**STAFF RECOMMENDATION**

**1200 Seventh Avenue N, 1204 Seventh Avenue N, and 1206 Seventh Avenue N  
July 19, 2017**

**Application:** New construction-infill

**District:** Germantown Historic Preservation Zoning Overlay

# SITE PLAN

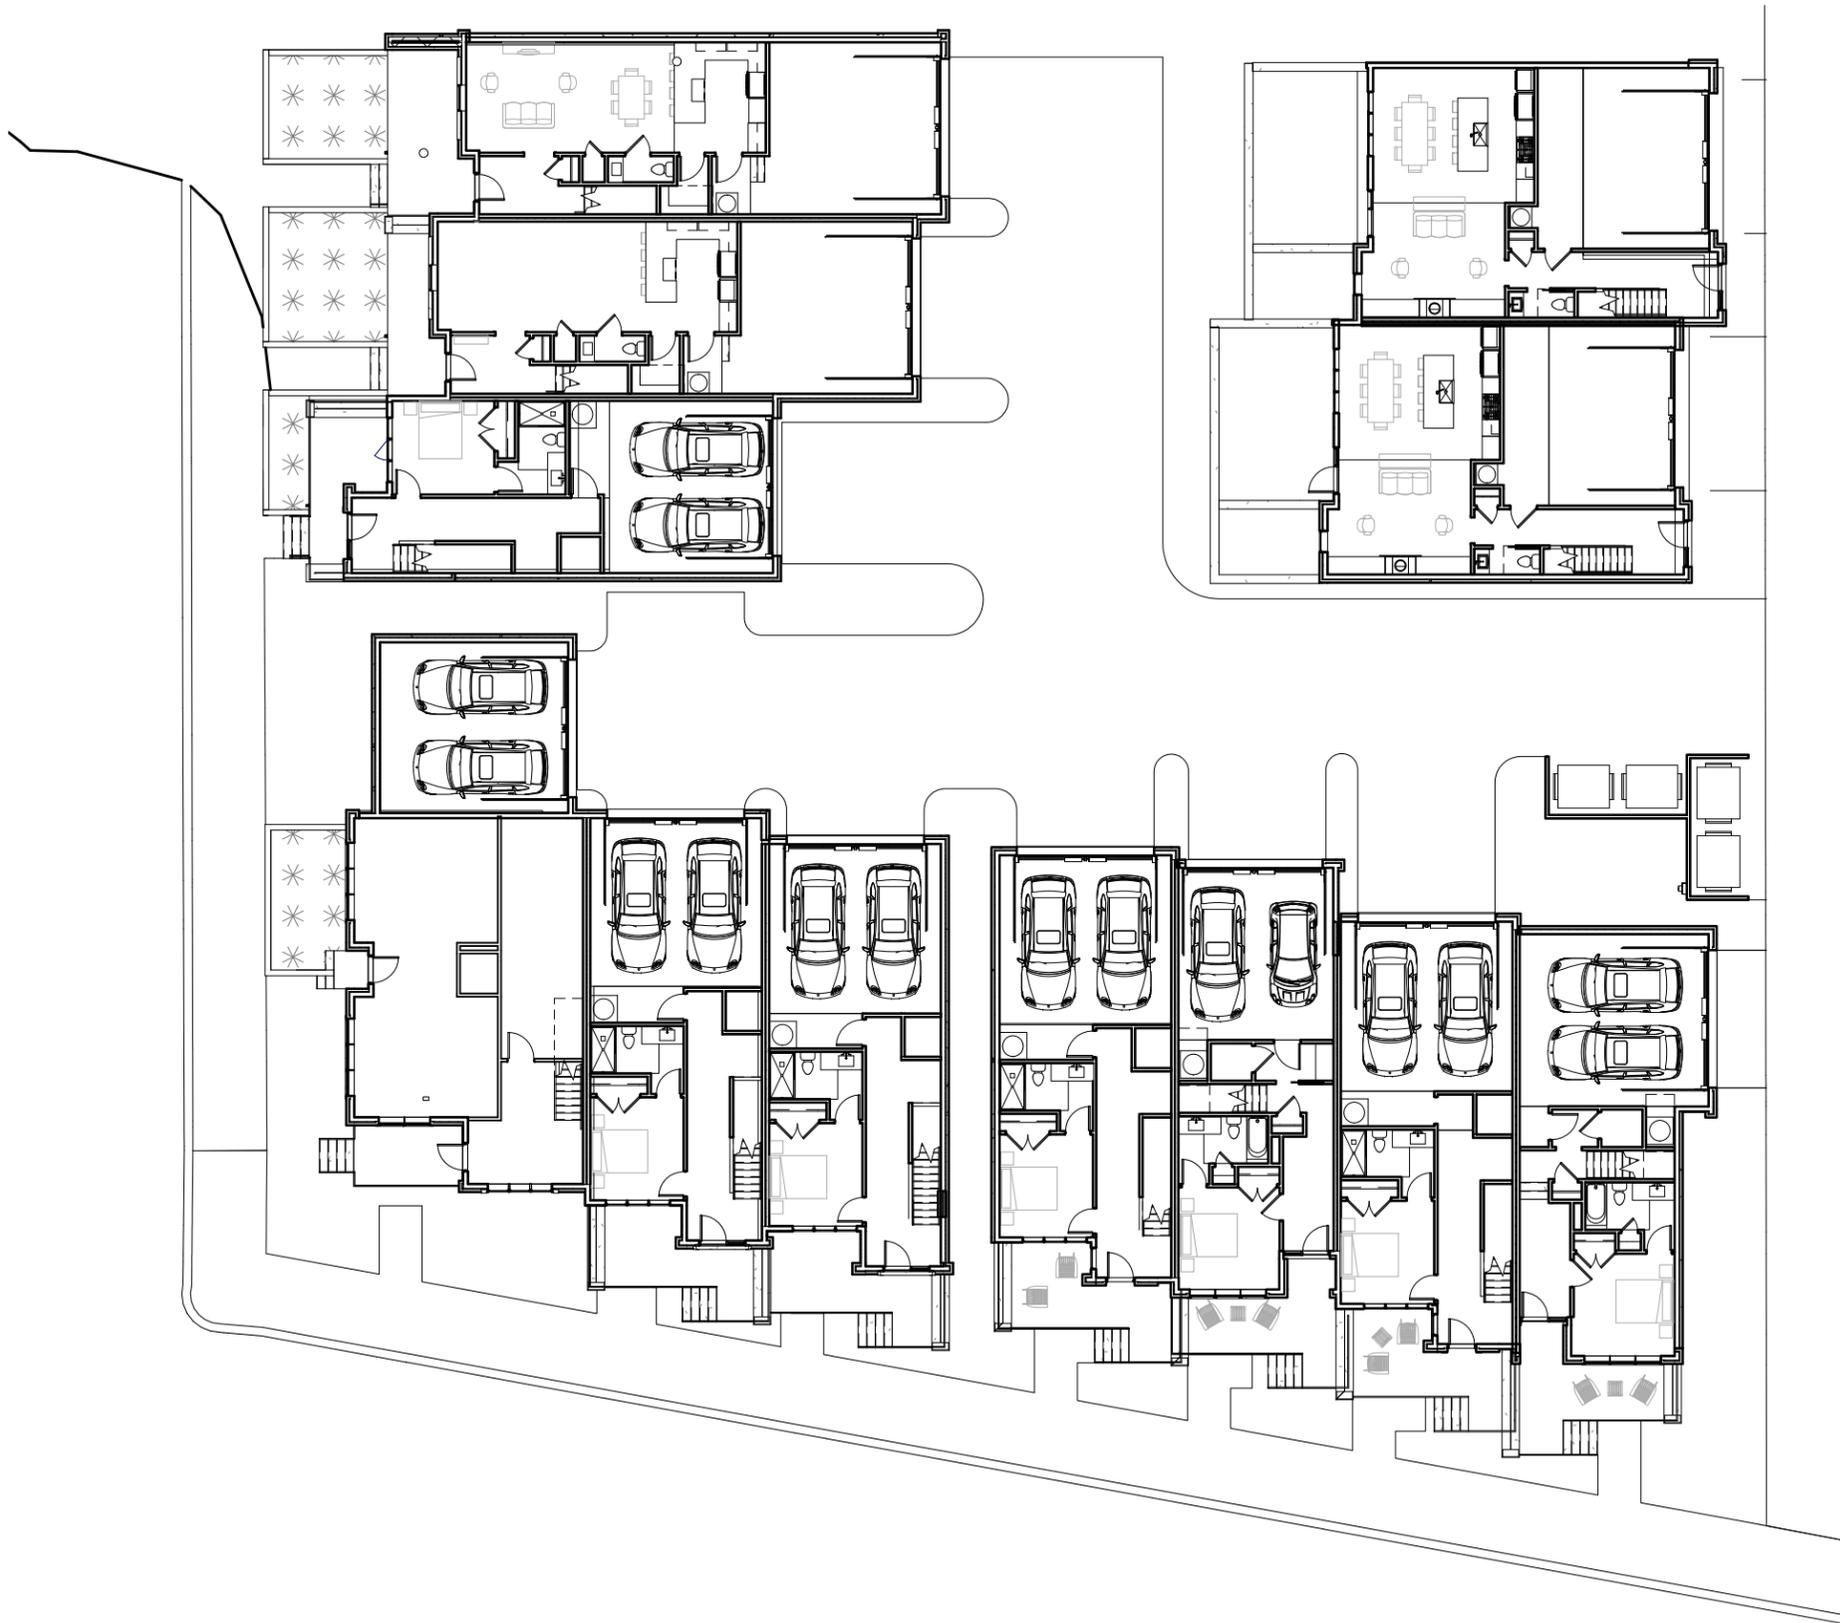
Setbacks, and Site and Building Planning: The townhouses along Madison Street will be grouped so that four are attached on the right/east side of the lot and three are attached on the left/west side of the lot. They are separated by a space of approximately seven feet (7'). Madison Street angles slightly between Sixth and Seventh Avenues, and the townhouses' front setbacks will angle and will be stepped to address the street's angle. The eastern most townhouse on Madison Street, which is the townhouse closest to the alley, will be located ten feet (10') from the alley at the front and approximately six feet (6') from the alley at the rear. It will have a front wall that is fourteen feet (14') from the sidewalk line and twenty-four feet (24') from the edge of the street. The three other townhouses in this row will have similar front setbacks.

The group of three townhouses on the western side of the lot will sit slightly closer to the street than the other townhouses, and will be approximately twelve feet (12') from the sidewalk line and twenty-one feet (21') from the line of the street. With the exception of the townhouses at the corner of Seventh Avenue North and Madison Street, the townhouses all have entry stoops/uncovered porches that are between six and ten feet (6'-10') deep. The townhouse at the corner of Seventh Avenue North and Madison Street has an eight by twelve (8'X 12') entry stoop at the corner, which is appropriate. This corner townhouse will be approximately nine feet (9') from the Seventh Avenue North sidewalk line and eighteen feet (18') from the line of the street.

The three townhouses that face Seventh Avenue North will step back to transition from the corner townhouse to the existing historic house at 1208 7<sup>th</sup> Avenue North. The southern-most townhouse will be set back five feet (5') from the sidewalk line and fourteen feet (14') from the line of the street. The other two townhouses will line up with the front setback of the historic house at 1208 7<sup>th</sup> Avenue North, which staff finds to be appropriate.

The two alley houses will be located behind the street-facing townhouses, and will face the alley. They will be between five and eight feet (5'-8') off the alley, which staff finds to be appropriate because the design guidelines state that structures should be a minimum of five feet (5') from the alley. Staff finds that the alley houses are appropriate because Germantown is a mixed use neighborhood, with several larger townhouse and multi-family developments. The lot is zoned for mixed use, multi-family, and a development that includes alley houses is in keeping with other developments approved by MHZC in the Germantown Historic Preservation Zoning Overlay. Staff finds that the development's setbacks and site and building planning meet Sections 2.1 and 2.2. of the design guidelines.

Mechanical: The locations of the mechanical equipment were not indicated on the drawings, and staff recommends that all mechanical systems be located on the roof, or in the interior of the development to reduce their visibility from the street in order to meet Section 2.8 of the design guidelines. The electrical meter will be placed off the alley, facing the interior of the lot in order to minimize its visibility. Staff finds that this meets Section 2.8. of the design guidelines.

Fences: No other fencing or perimeter walls were indicated on the site plan. Staff will need to approve all fencing and perimeter walls to ensure that they meet Section 5.1 of the Germantown design guidelines.

Parking: Each townhouse will have attached parking on the ground floor for two cars. For the street-facing townhouses, the parking will be on the interior of the lot, not visible from the street. The alley houses will have attached parking on the ground floor, accessed via the alley, with garage doors facing the alley. All parking will be accessed via the alley. No curb cuts will be created on Seventh Avenue North or Madison Street. Staff finds that the proposed parking meets Section 5.3 of the Germantown design guidelines.

**ELEVATIONS  
(STREET  
SIDE)**  
07.10.2017

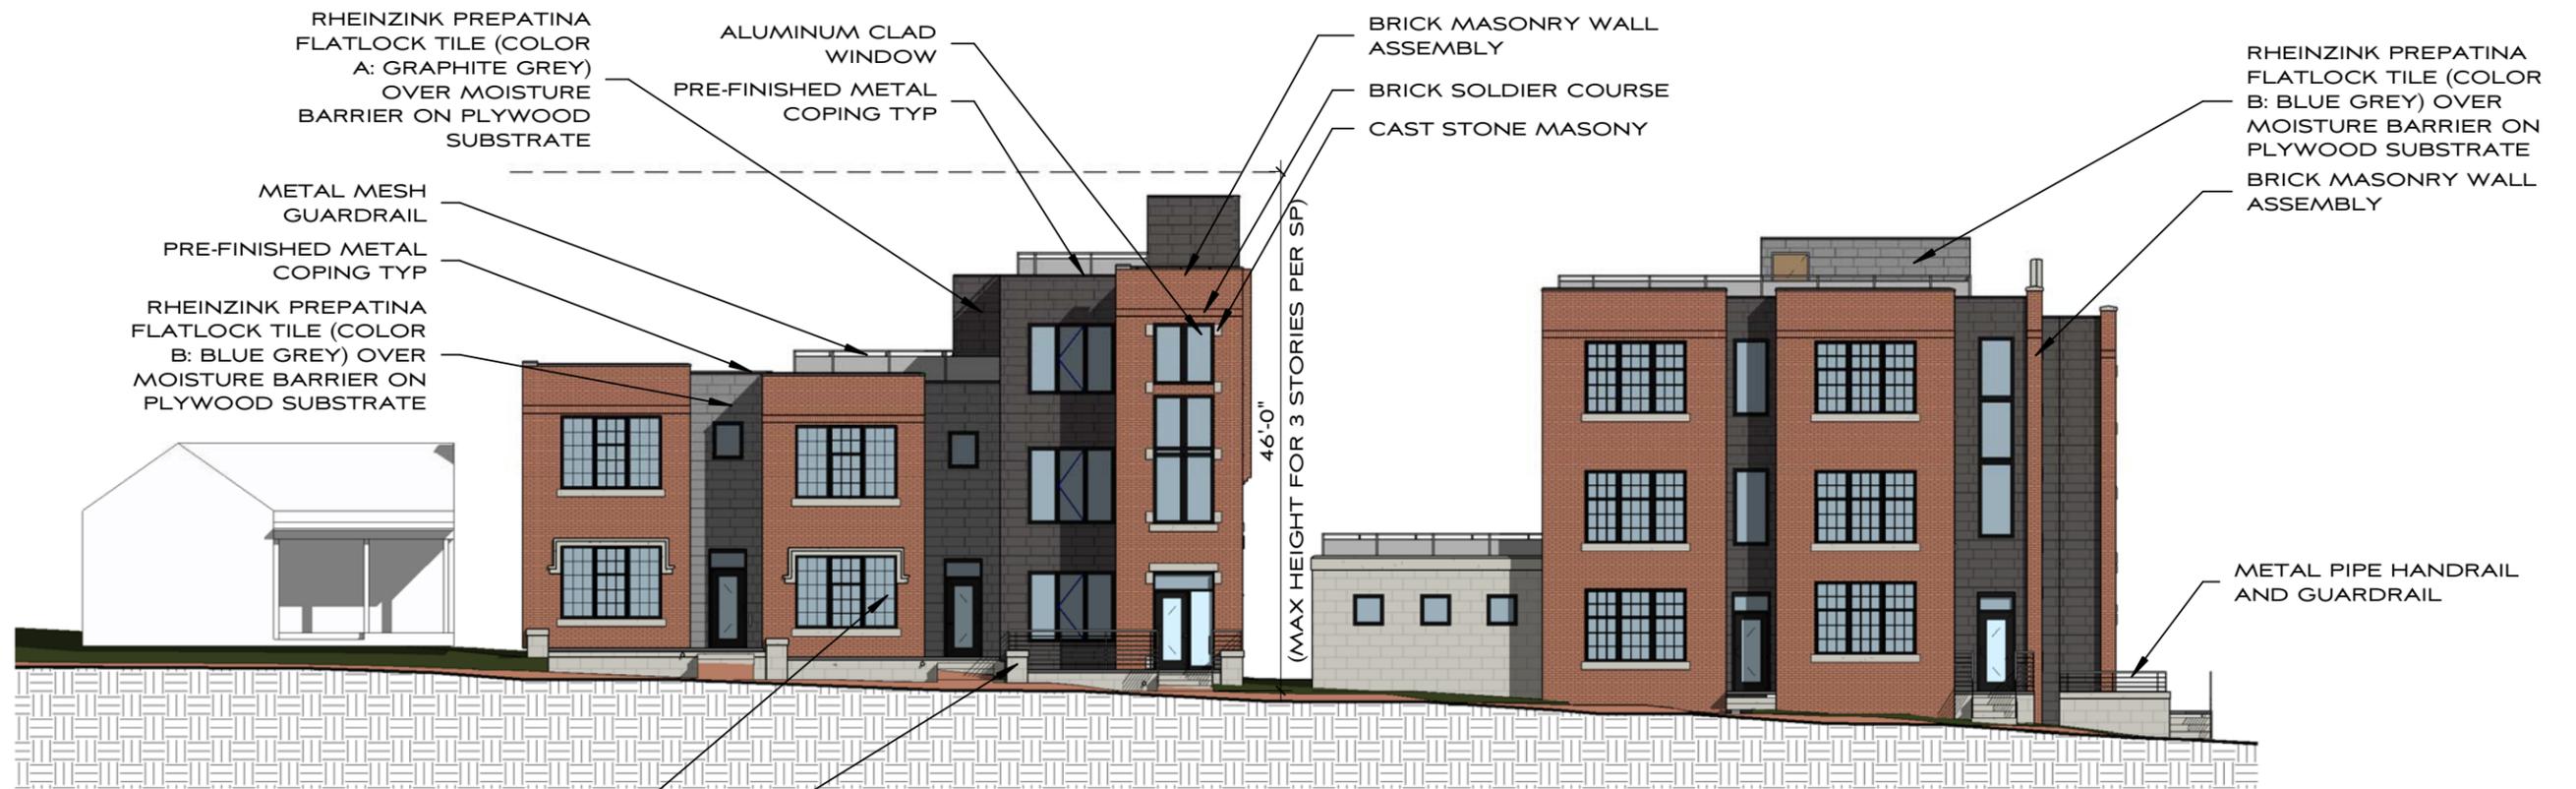
Height, Scale: Although the project has changed from an apartment building to townhouses, the overall height and scale of the new design is similar to what MHZC previously approved. The previously apartment building along Madison Street was three stories in height, with a maximum height of forty-two feet (42') from grade. The new townhouse design is also three stories, with a primary height of thirty-nine to forty-one feet (39'-41'), depending upon grade. Four of the seven townhouses along Madison Street have stair bulkheads, which will add another six feet (6') above the parapet, and

For the three townhouses that face Seventh Avenue North, the southern-most townhouse will be three stories and thirty-eight feet (38’) in height, not including the seven foot (7’) tall stair bulkhead. The other two townhouses will be just two stories in height, making the transition from the three-story multifamily development to the one-story historic house next door at 1208 7<sup>th</sup> Avenue North. The two-story townhouses will have heights of approximately twenty-eight feet (28’), which will be about seven feet (7’) taller than the historic house at 1208 7<sup>th</sup> Avenue North.

Foundation: The proposed buildings will not have defined foundation lines; the brick or metal façade material will extend to grade. Staff recommends that there be a change in material to show a foundation line, as historically, structures had a delineated foundation line. This condition will ensure that the foundations meet Section 2.3 of the Germantown design guidelines.

Windows: The fenestration pattern for the proposed development ensures that there is an appropriate proportion of solid-to-void in the design. The development's facades on Seventh Avenue North and Madison Street have window patterns that address the street and do not result in large expanses of walls without a window or door opening. Windows within masonry walls will be recessed a minimum of two inches (2"), which is appropriate. Windows will be aluminum, and staff recommends approval of the final window selection prior to purchase and installation. Staff finds the proposed windows to meet Section 2.6 of the design guidelines.

1. There be a change in material at the foundation line;
2. Staff approve brick and stone samples;
3. Staff approve the metal cladding color and texture;
4. Staff approve the final selection of windows and doors;
5. Staff approve the design of all balcony and stair railings;
6. All mechanical systems be located on the roof, or in the interior of the development to reduce visibility from the street;
7. Staff approve any fence or walls not indicated on the plans; and
8. Staff approve all exterior lighting.
